Sheet: /
File: FDRbox.sch

Title: FDRbox v0.1

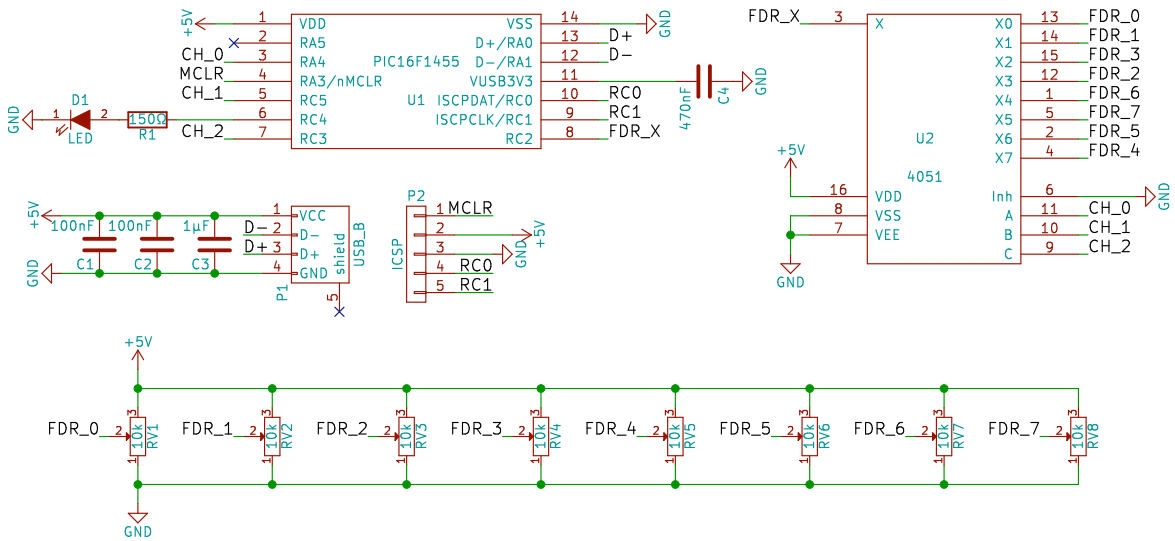
Faders are connected according to grey code.
FDR_6 and FDR_7, FDR_4 and FDR_5 have to be swapped.
Use regular order in next revision.
